City of Ontario

ADDENDUM NO. 3

D&C23-015 Anthony Munoz Gymnasium

Today's Date is Friday, September 11, 2026

SHEET: E1.1

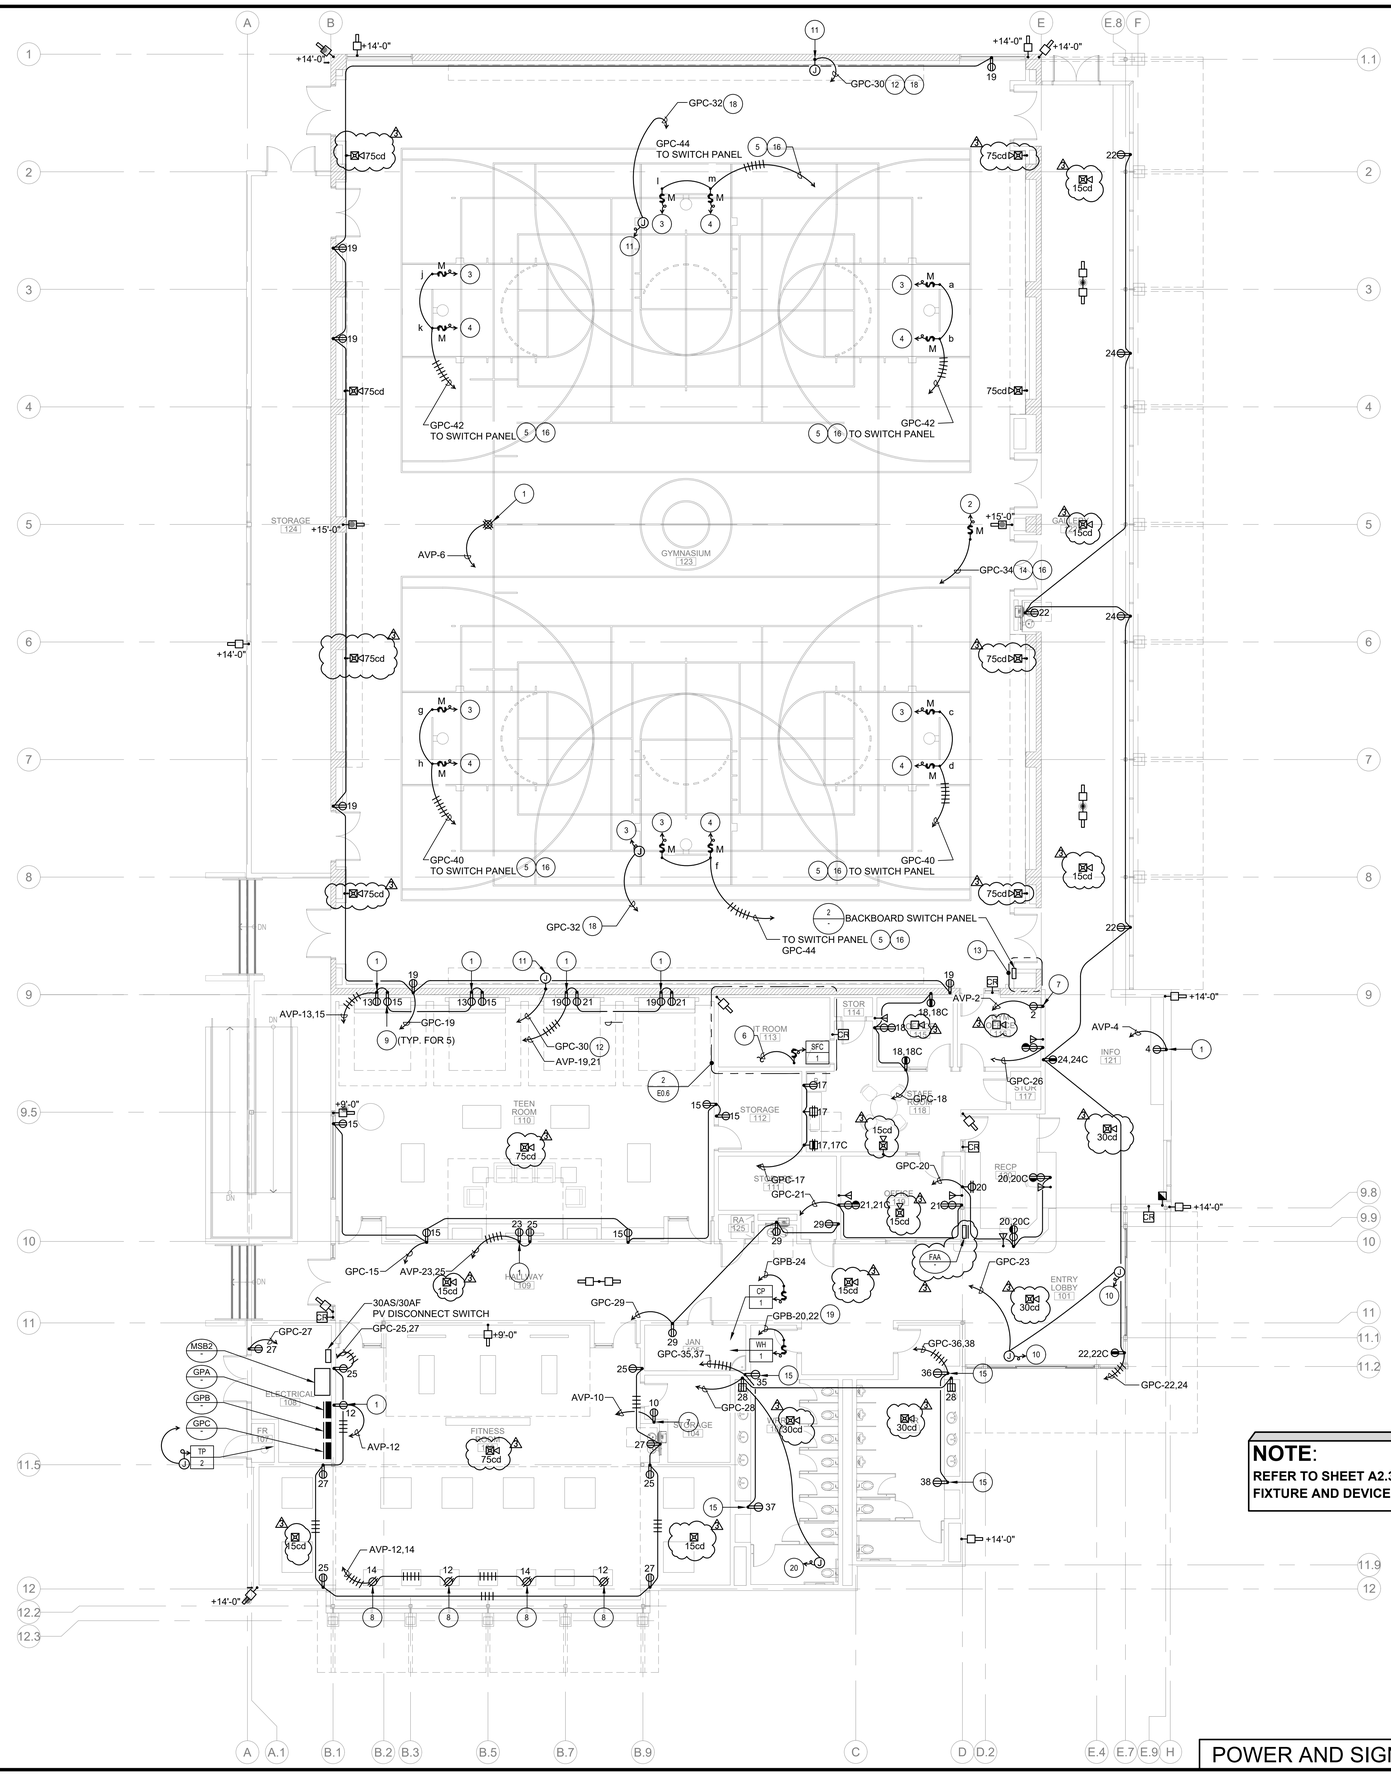
1. E0.1 Symbol List and General Notes
    a. Added symbols for the Fire Alarm Control Panel and Fire Alarm Enunciator Panel
2. E0.4 Single Line Notes and Details
    a. Added Notes 2 and 3 to Keynotes.
    b. Added new Circuit Breaker and modifications to Main Switchboard in Single Line Diagram 1.
3. E0.6 Enlarged Electrical Room and Details
    a. In Main Electrical Room Plan Detail 1 added location for Fire Alarm Control Panel
    b. Omitted Detail 9 for Light Bollard Fixture Type S2.
4. E0.7 Panel Schedule
    a. Panel GFB – Revised the panel size from 225 A to 400 A.
    b. Panel GBC – Added emergency battery inverter to panel.
5. E1.1 Site Plan

a. Added circuit for power/lighting at Ground Monument Sign.

SHEET 1 OF 2
CONTRACT
ACCOUNT
DWG. NO.

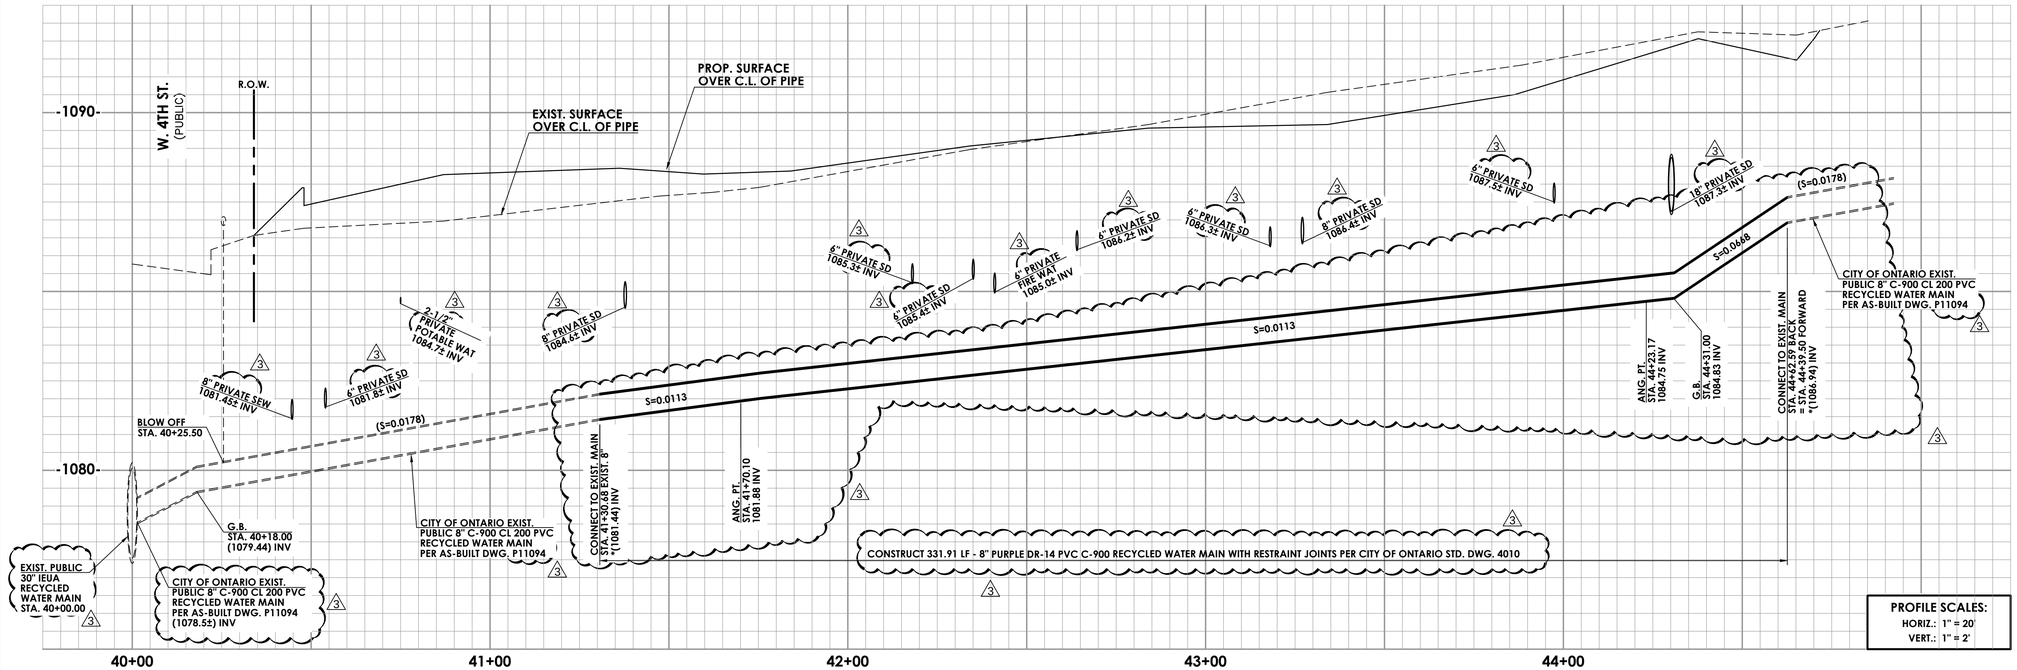
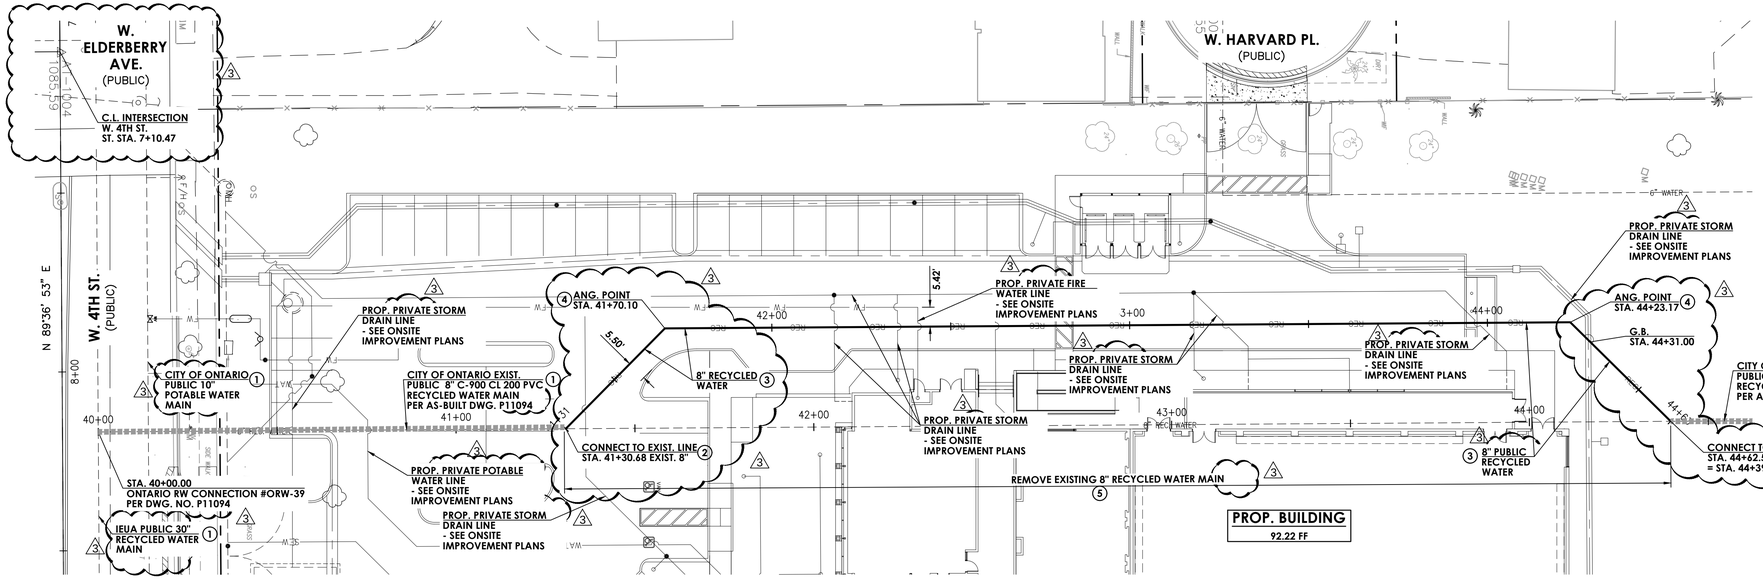
a. Revised Title Block.
b. Added Basis of Bearings, Reference Drawings and added to Legend.
d. Revised Construction Noted 2, 3 and 4.
e. Revised quantity of Construction Notes 3, 4 and 5.

SHEET 2 OF 2
CONTRACT
ACCOUNT
DWG. NO.

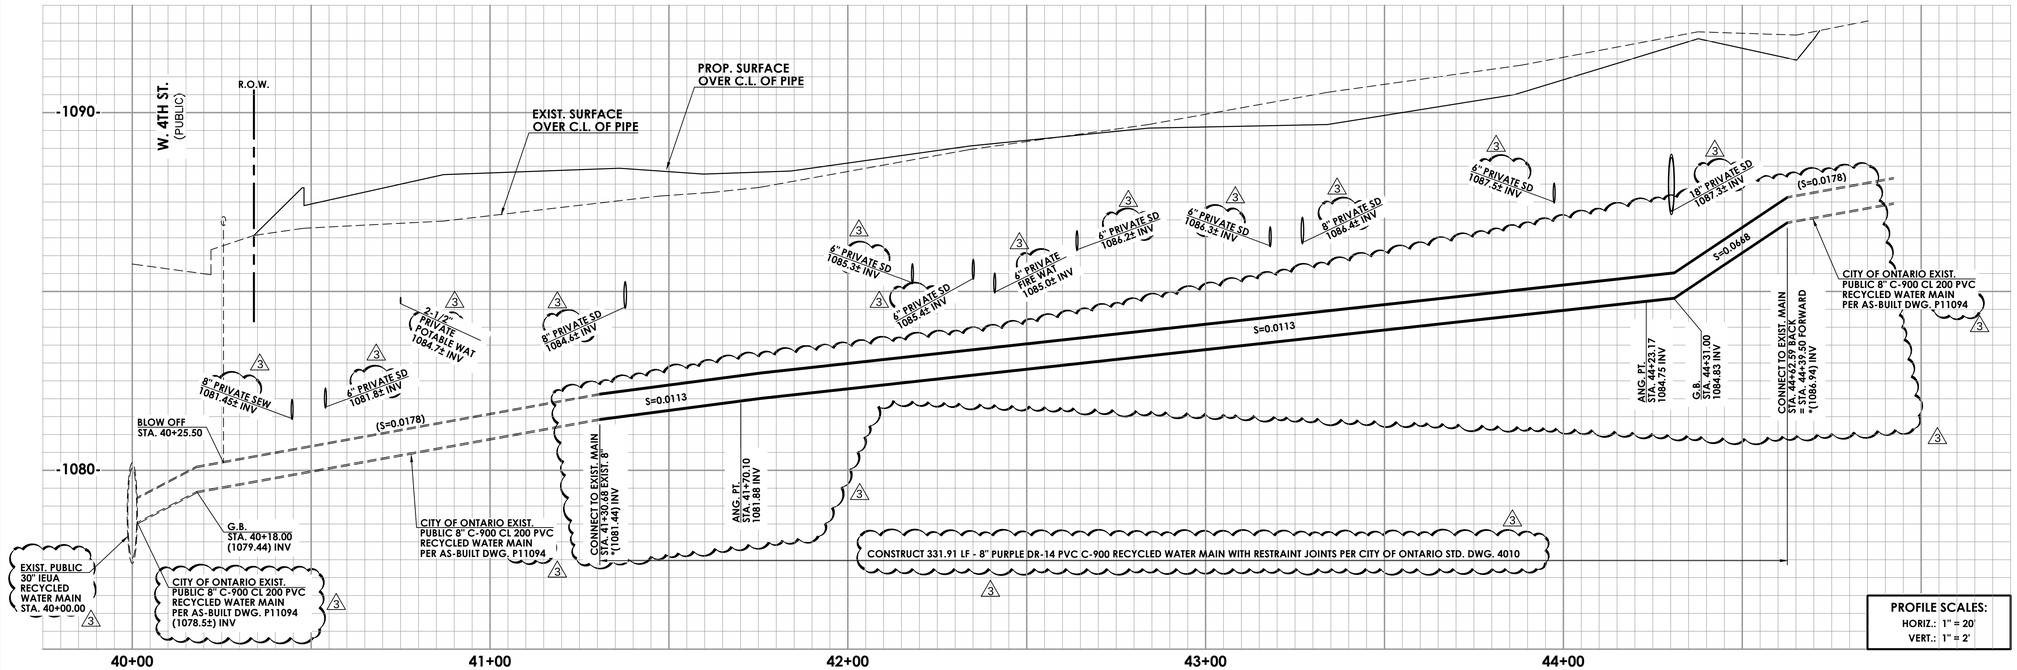
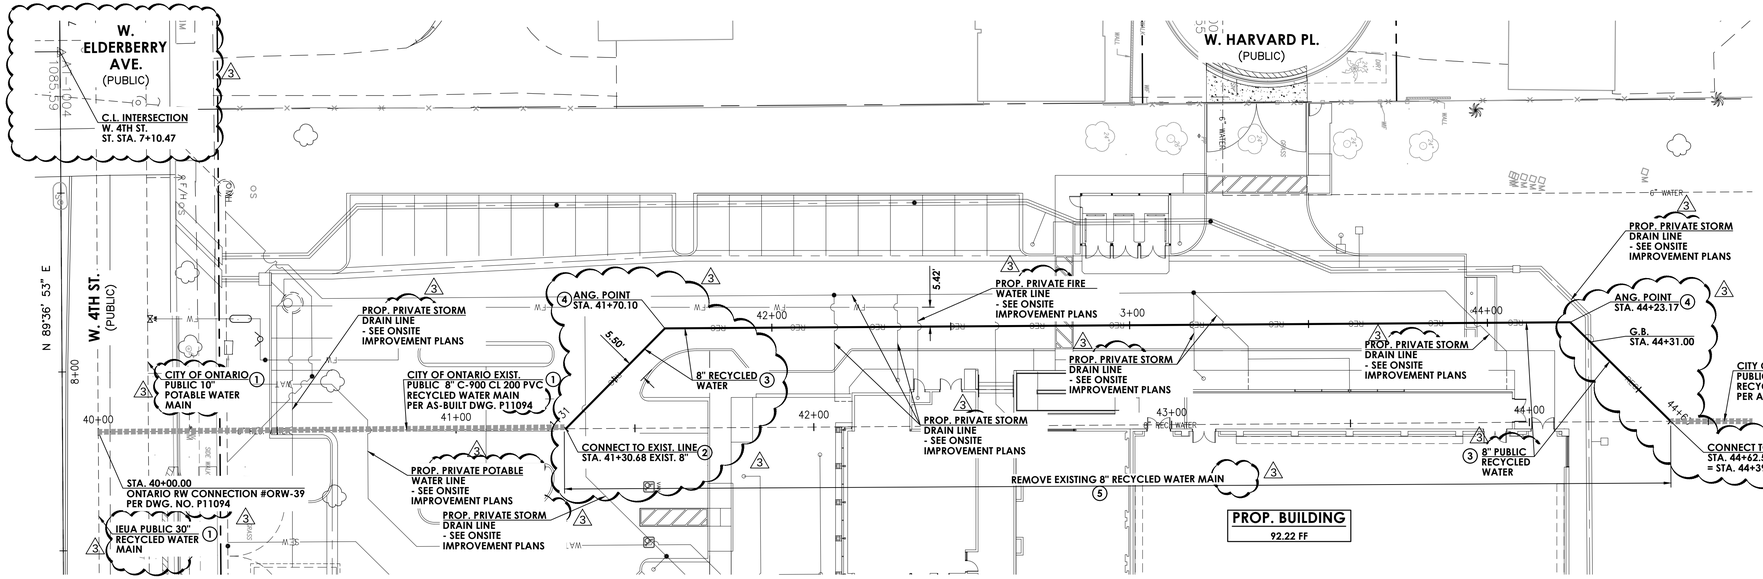
2. Sheet 2:
a. Revised Title Block.
b. Revised Construction Notes 2, 3 and 4.
c. Added 45-degree bends to recycled water line.
d. Added street stationing.
e. Revised callouts for existing and proposed utilities.
f. Revised profile of recycled water line due to 45-degree bends.
g. Screened back linework not in street scope.
